BROWNS FERRY NUCLEAR PLANT (BFN) – UNITS 1, 2, AND 3 - TECHNICAL SPECIFICATIONS (TS) CHANGES TS-431 AND TS-418 – EXTENDED POWER UPRATE (EPU) – RESPONSE TO ROUND 19 REQUEST FOR ADDITIONAL INFORMATION (RAI) (TAC NOS. MD5262, MD5263, AND MD5264)

TENNESSEE VALLEY AUTHORITY
BROWNS FERRY NUCLEAR PLANT (BFN)
UNITS 1, 2, AND 3

RESPONSE TO ROUND 19 REQUEST FOR ADDITIONAL INFORMATION (RAI)

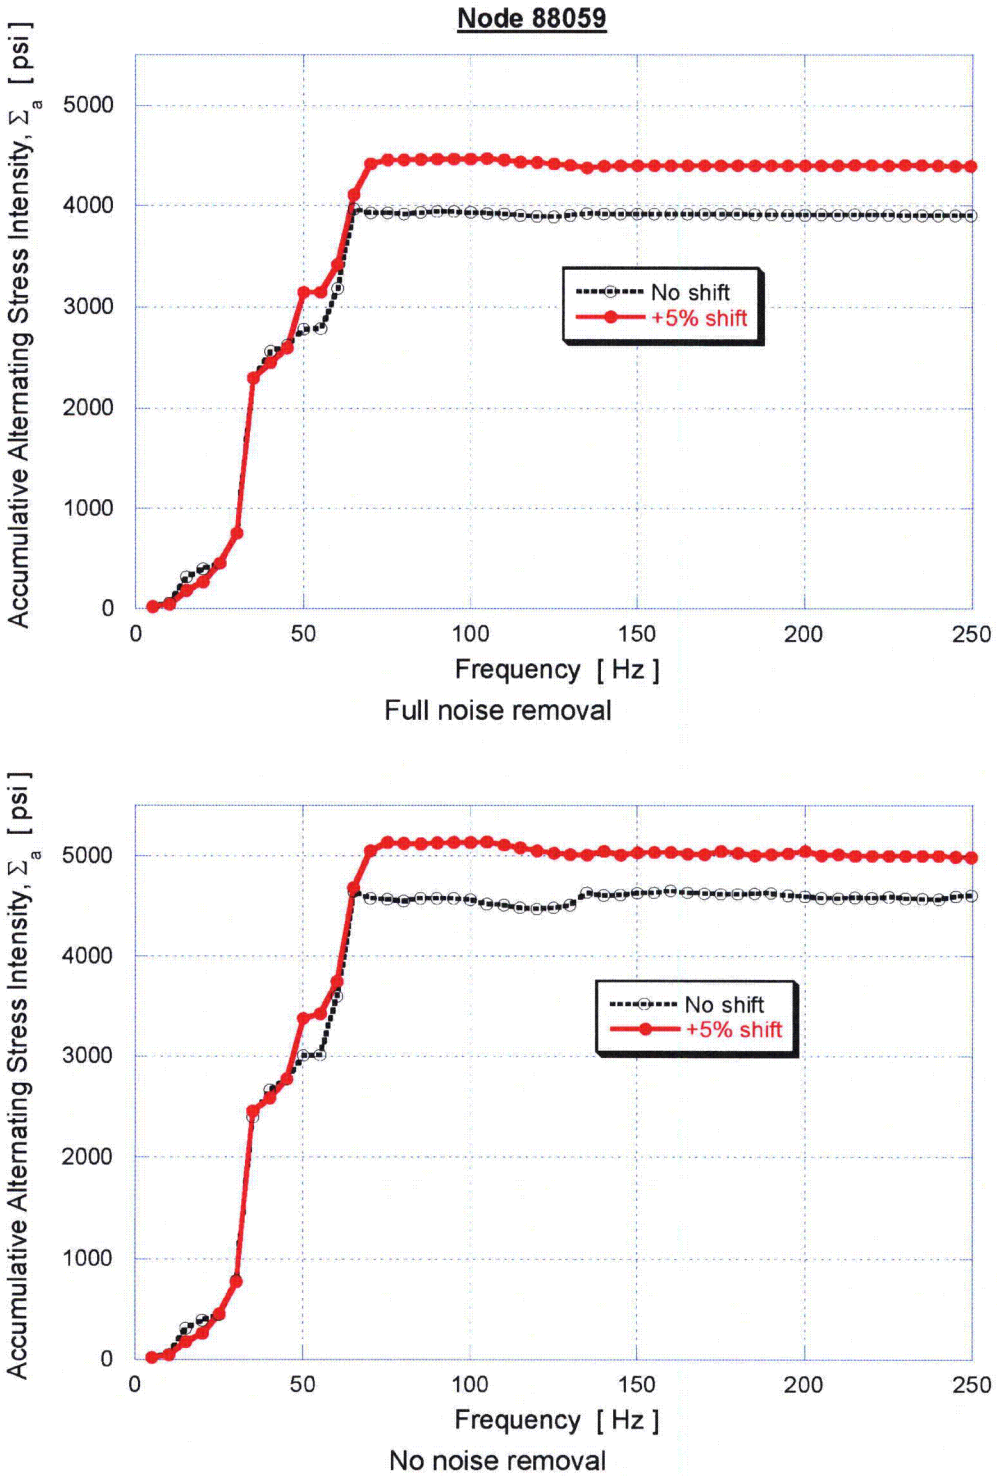
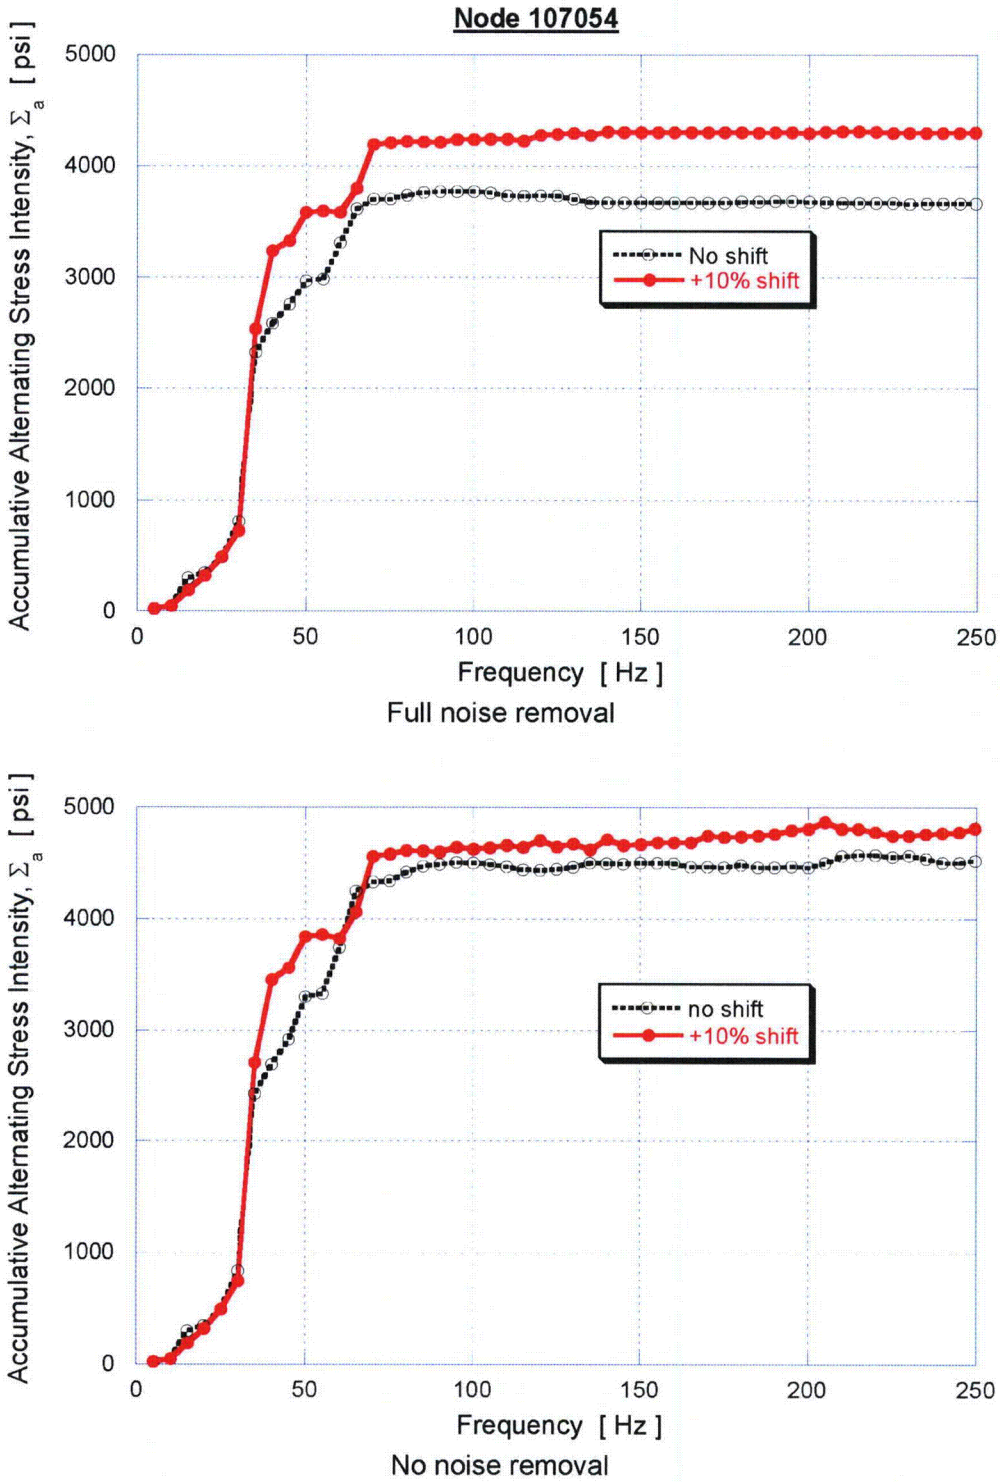
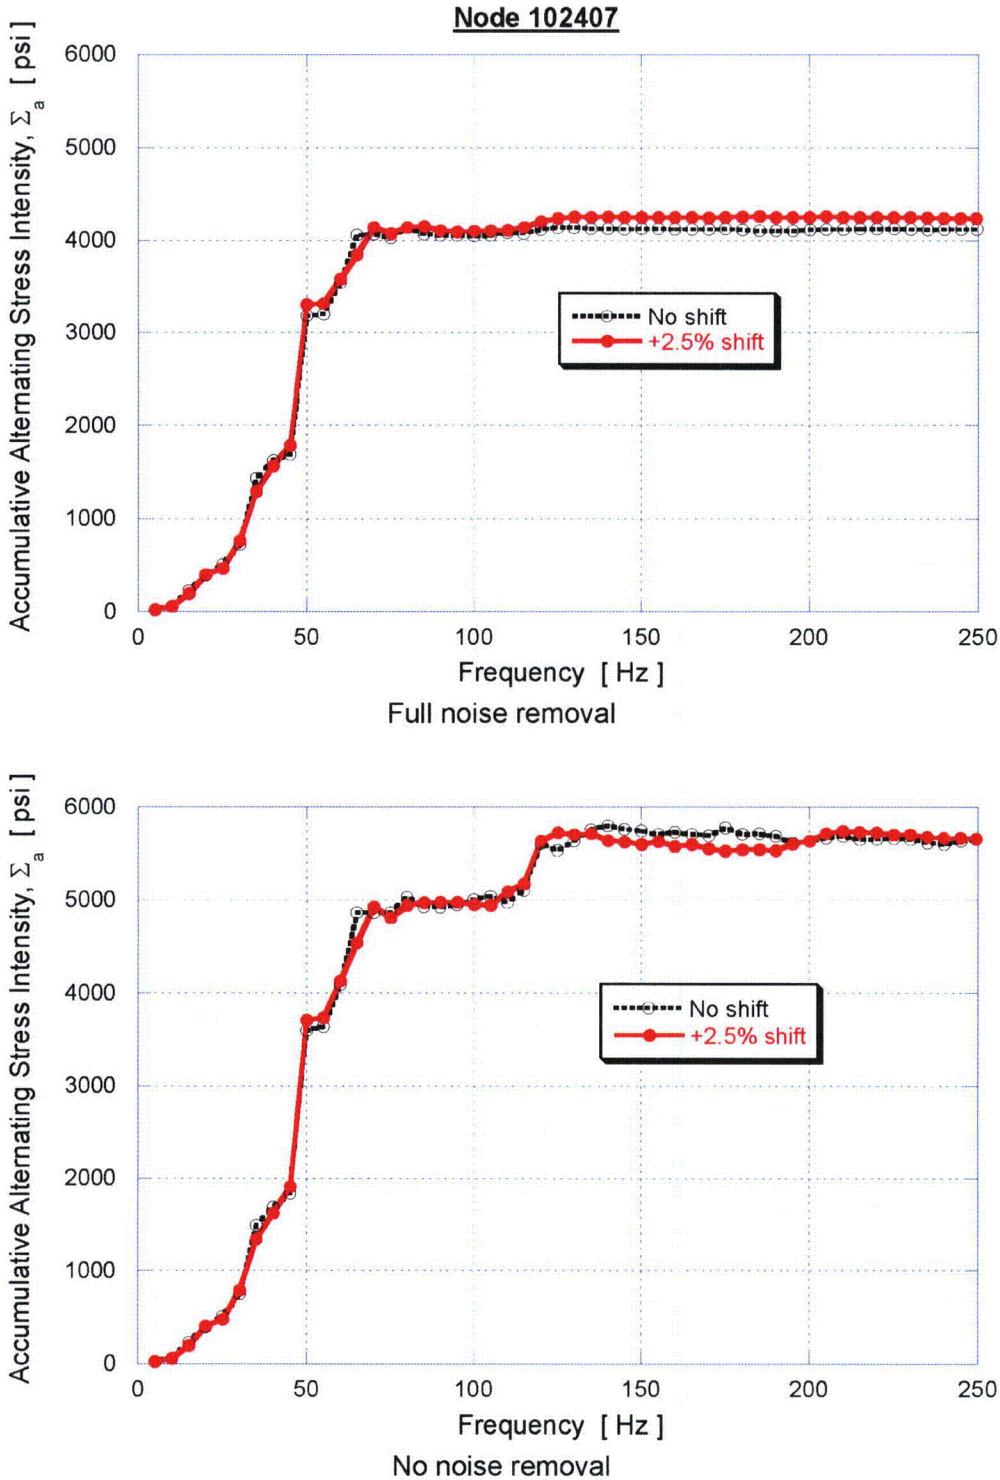
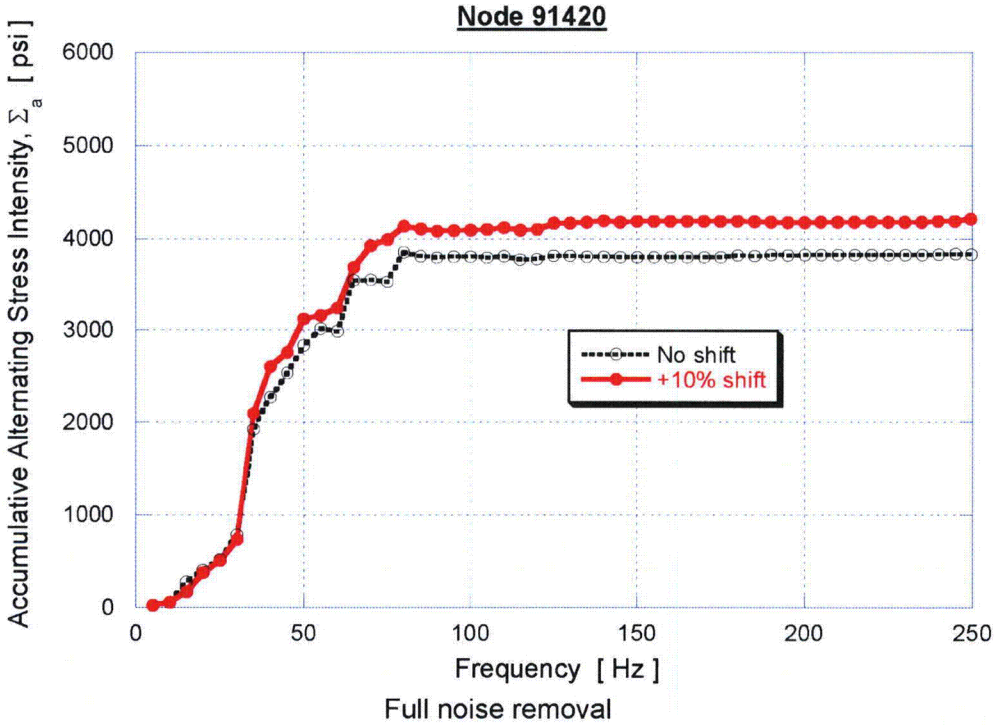
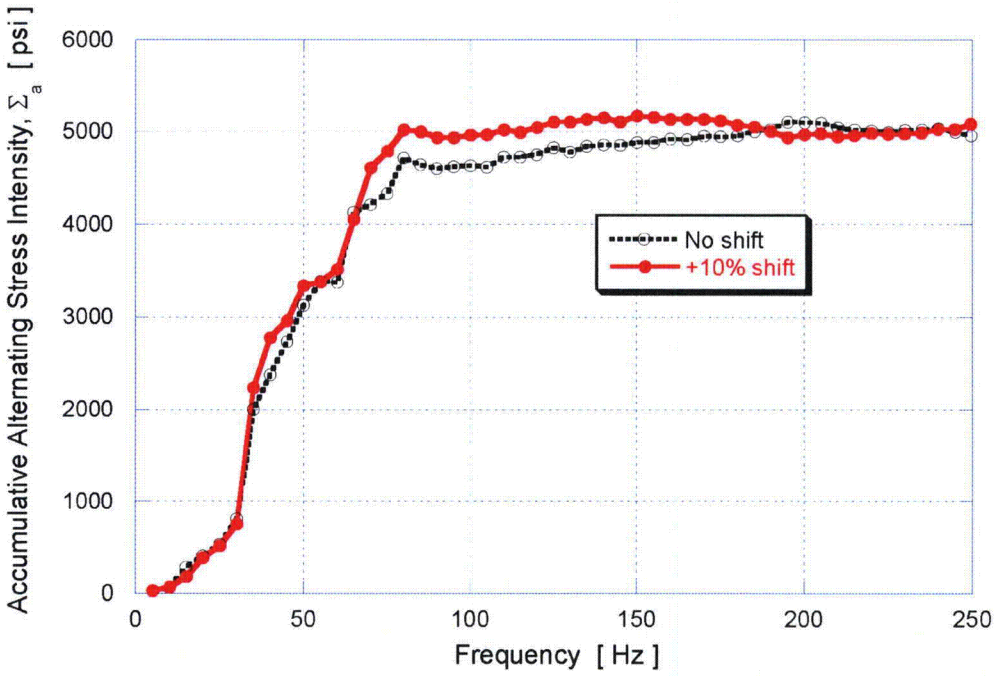
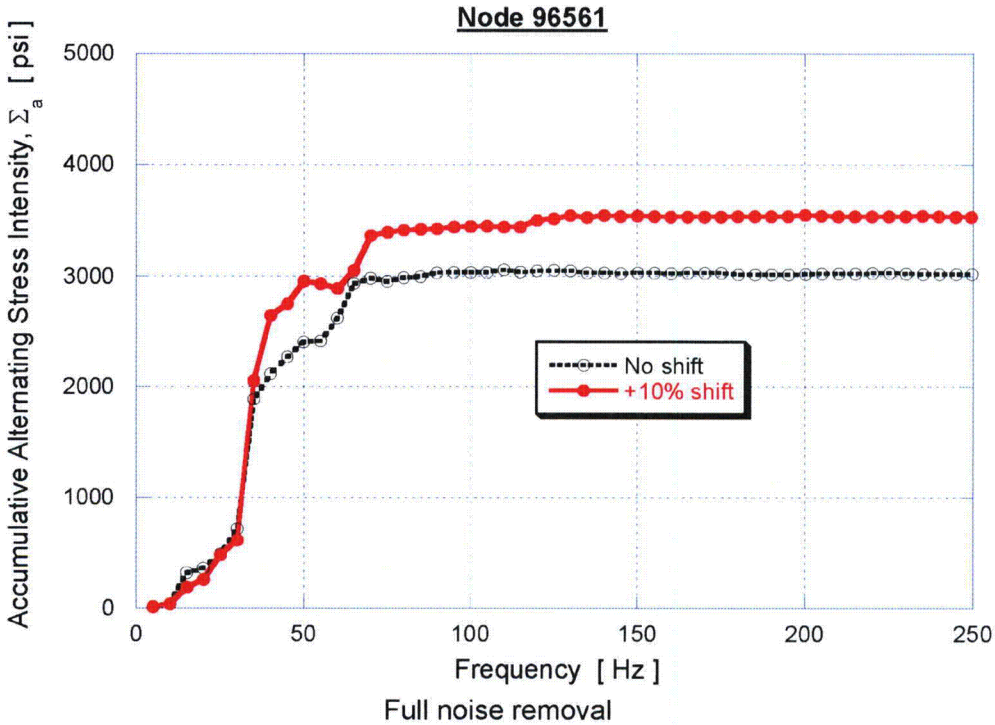
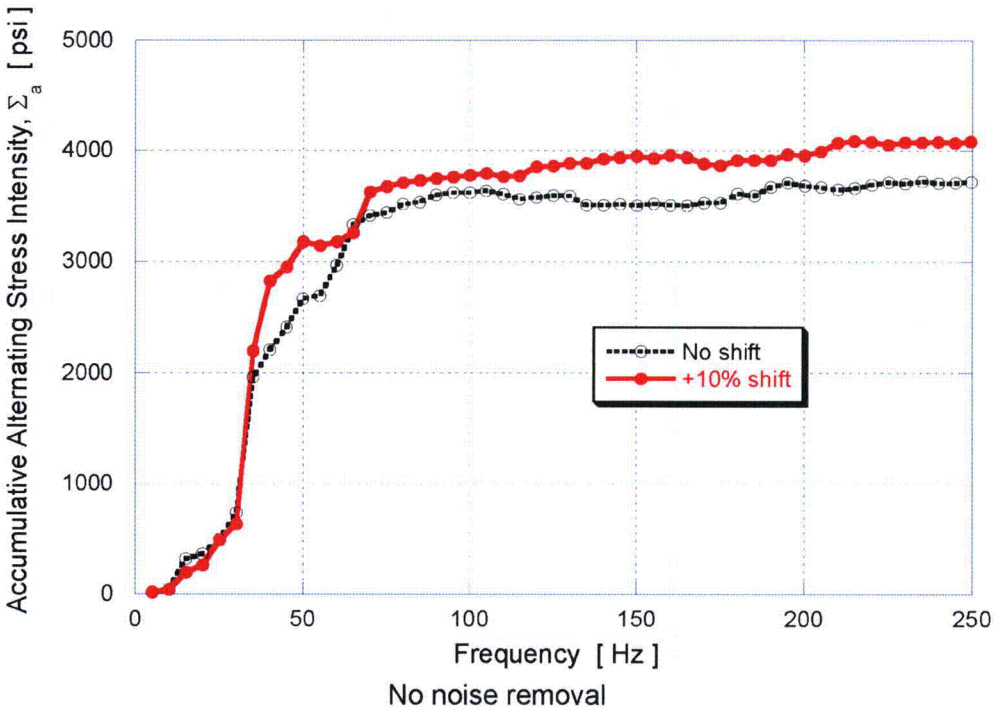
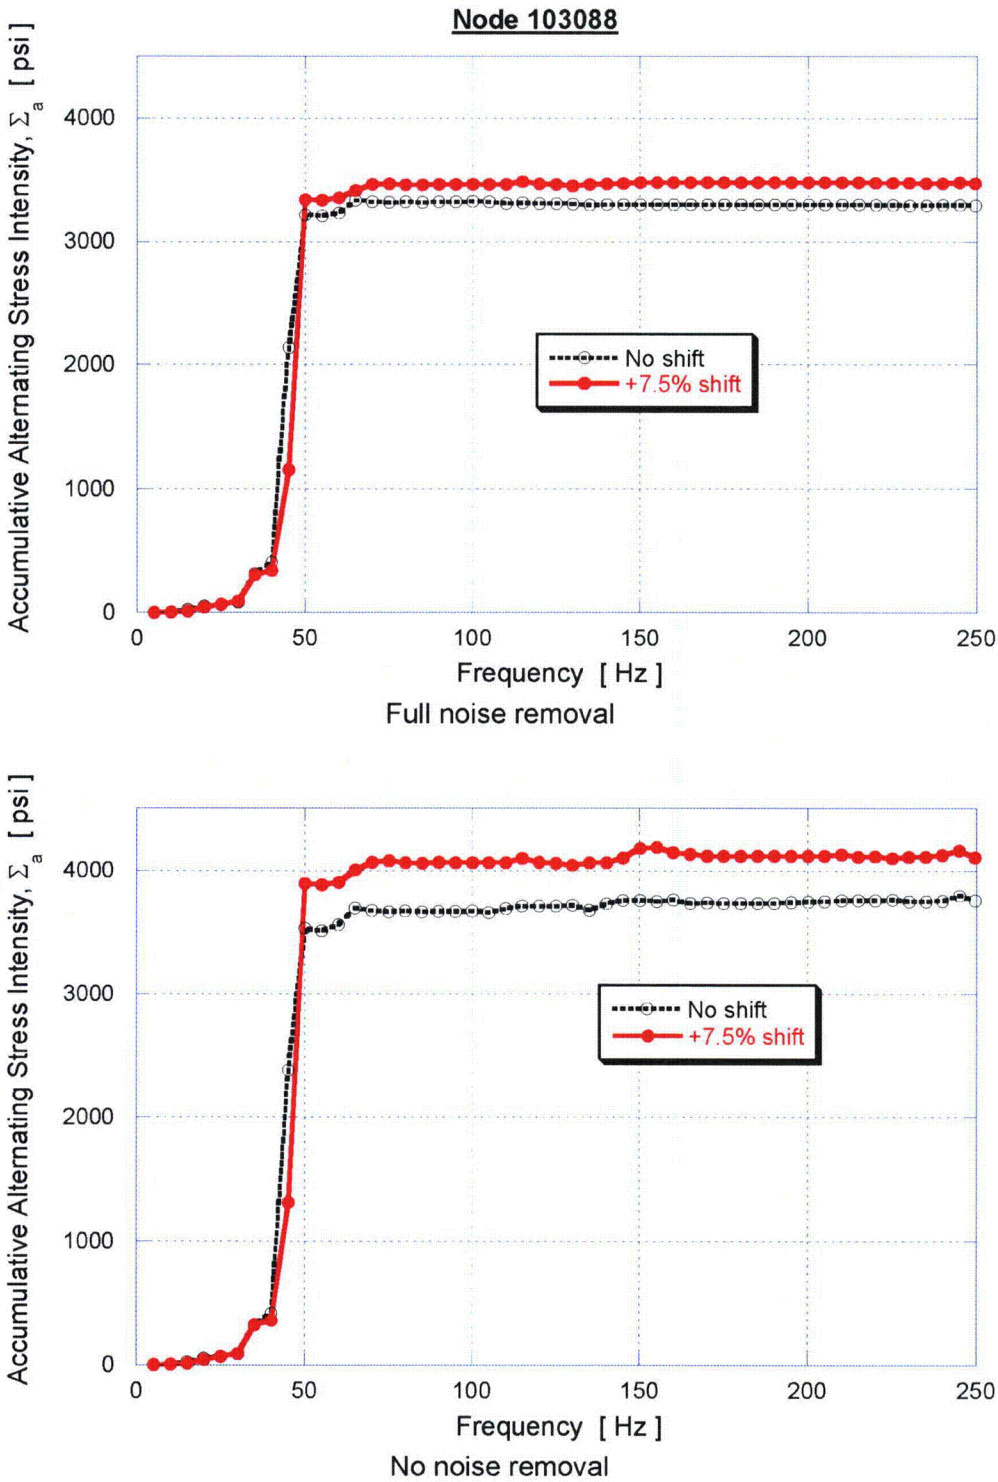
The accumulated stress plots presented in response to RAI EMCB 170/138 show that the alternating stress amplitude increases little beyond 100 Hz. Please explain this observation. Provide similar stress plots when unfiltered MSL signals are used for the stress analysis of Unit 1 dryer. Please explain the differences between the plots for filtered and unfiltered signals.

Figures EMCB.183-1a through j shows the accumulative stress intensities without noise removal. To facilitate comparison, the accumulative alternating stress intensities presented in the response to RAI EMCB 170/138 using noise removal algorithm (i) above are also shown. As before, the accumulative alternating stress intensity, $\Sigma_a(f)$, is defined as the alternating stress computed when zeroing all stress harmonics for frequencies above f. It is computed in 5 Hz increments as explained in the response to RAI EMCB 170/138.

In all cases, with or without noise removal, the dominant increases in the accumulative alternating stress intensity occur below 100 Hz. With noise left in, node 104539 exhibits the strongest increase above 100 Hz, though still less than the rise below 100 Hz. At the worst case frequency shift (+10%) for this case, the increase in alternating stress intensity between 0 to 100 Hz is 3560 psi. The remaining increase above 100 Hz is 604 psi, or less than 17% of the 0-100 Hz rise. The other node with a significant increase above 100 Hz is node 102407 which shows a jump at approximately 120 Hz. The total increase for this node (noise left in and the worst case frequency shift of +2.5%) above 100 Hz is 703 psi which is 14% of the 0-100 Hz stress rise (4955 psi).

The differences between the filtered and unfiltered stress responses can mostly be attributed to higher rises (with noise left in) in the 35-65 Hz range. This is consistent with the fact that the noise removal algorithm reduced the signal amplitude where the noise is high. These reductions are quantified in the response to RAI EMCB 170/138.
